HISTORIC AND DESIGN REVIEW COMMISSION

Agenda Item No: 36

HDRC CASE NO: 2015-141
ADDRESS: 114, 130, 134 SOLEDAD ST, 140 E HOUSTON
LEGAL DESCRIPTION: NCB 106 BLK LOT A12 THRU A16 114 TO 128 SOLEDAD ST
ZONING: D H HS RIO-3
CITY COUNCIL DIST.: 1
DISTRICT: Main/Military Plaza Historic District
LANDMARK: Devine Building
APPLICANT: Travis Jeakins/Woodbine Development
OWNER: Service Lloyds Insurance Co
TYPE OF WORK: Demolition with new construction
REQUEST:

PROPOSED DEMOLITION:

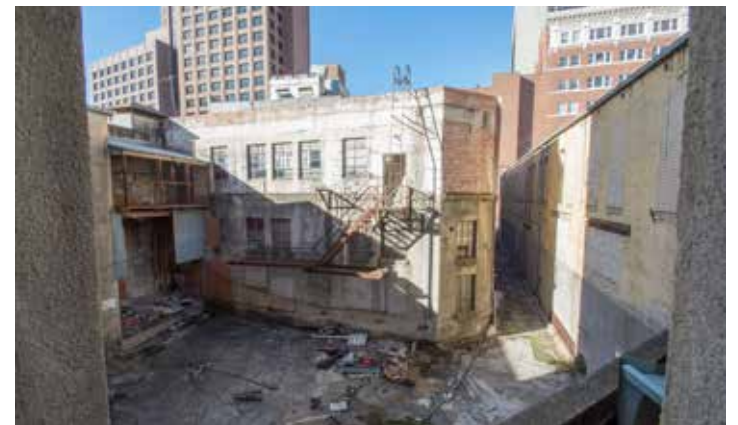
Woodbine proposes to remove all of the structures on the parcel with the exception of the façade fronting Soledad Street. This façade will be protected and renovated in place.

EAST ELEVATION

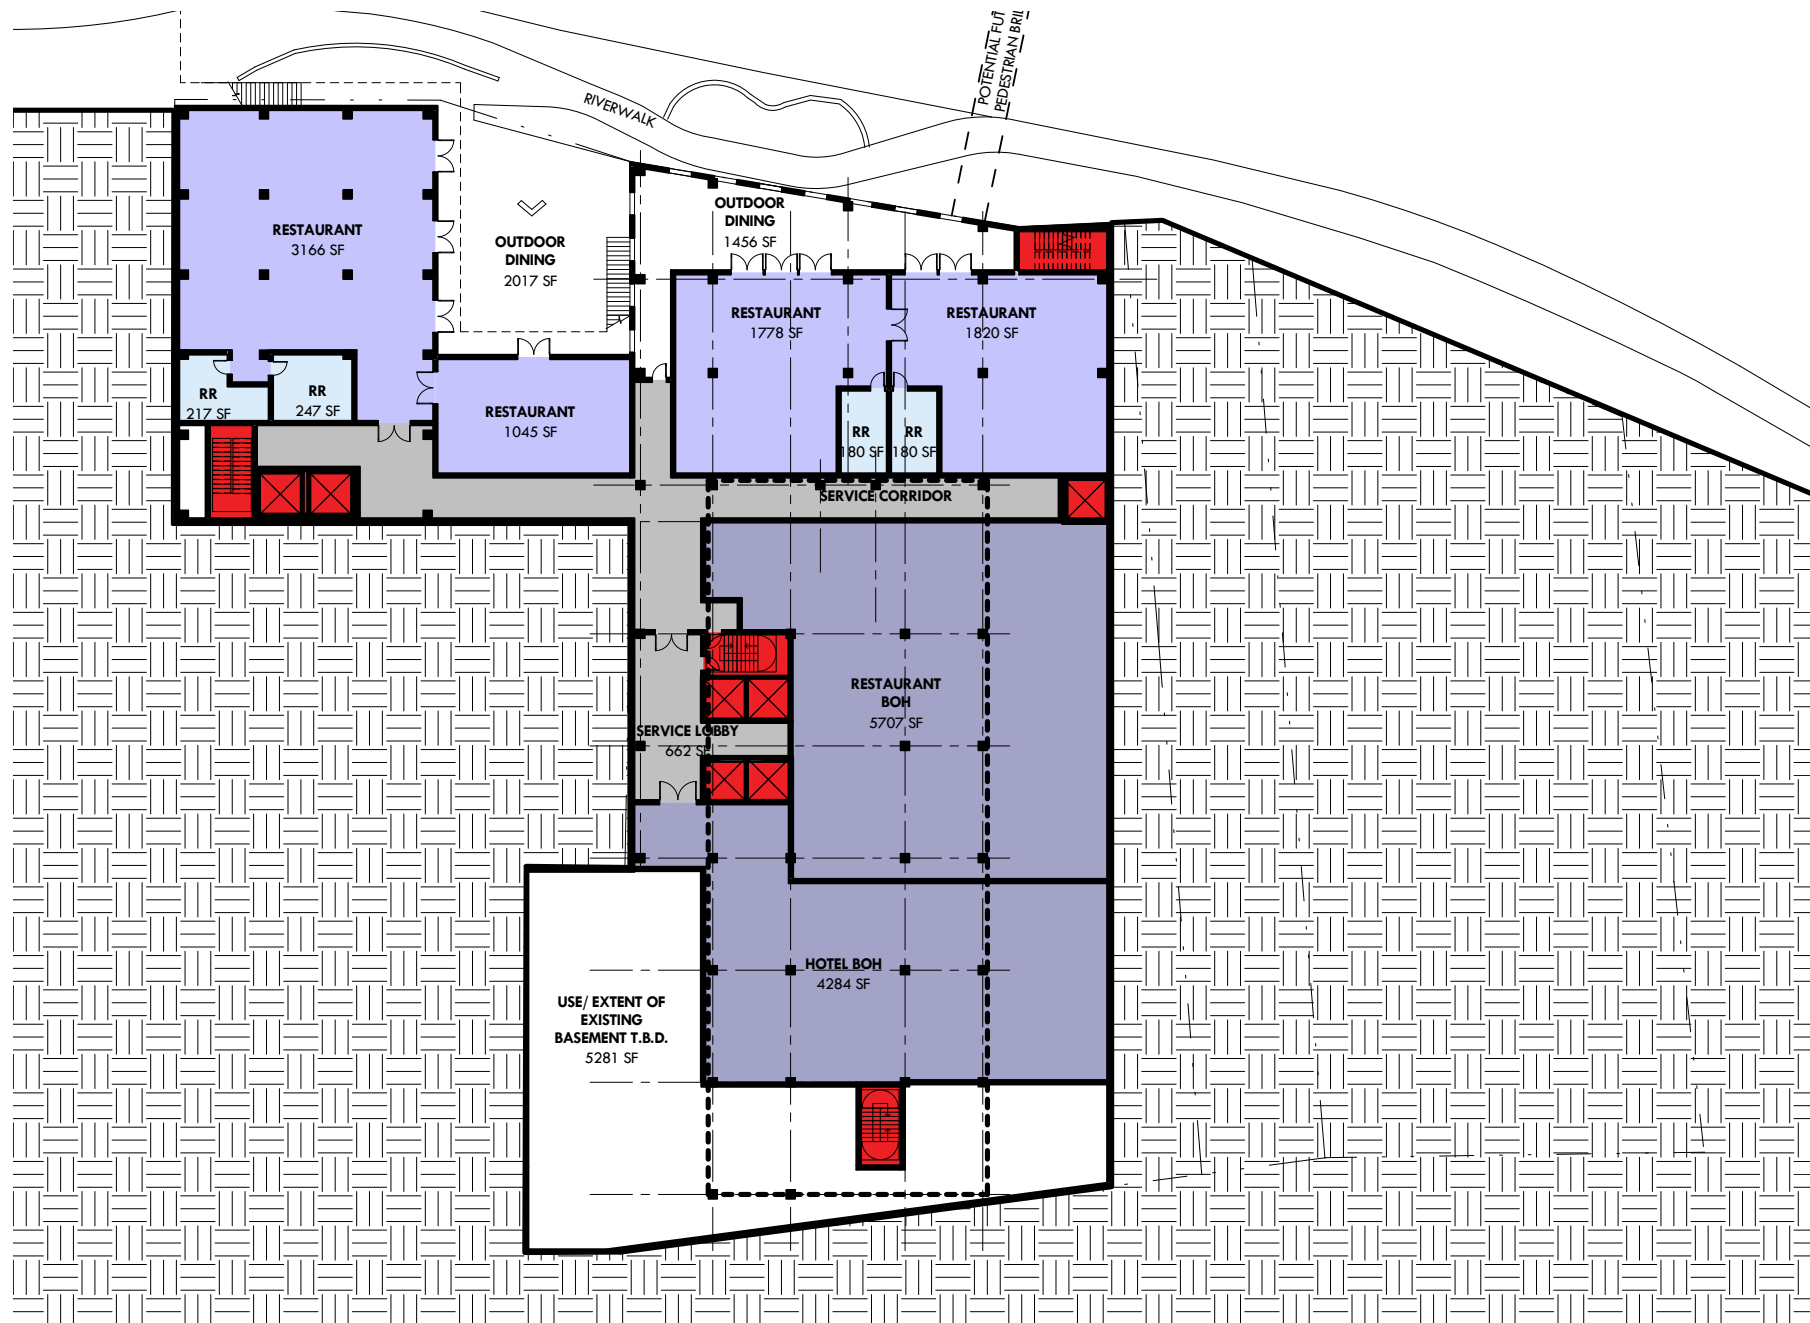
- 1) The applicant be allowed to remove the entire 1912 stone wall and construct a new wall in the same location reusing the dismantled stones (UDC 35-680(a)1; and
- 2) The Soledad street elevation needs to better reflect the rhythm and pattern of the adjacent buildings as per UDC 35-674(b)(1)A. "Treatment of architectural facades should contain a discernable pattern of mass to void, or windows and doors to solid mass. Openings should appear in a regular pattern, or be clustered to form a cohesive design. Architectural elements such as columns, lintels, sills, canopies, windows and doors should align with other architectural features on the adjacent facades."
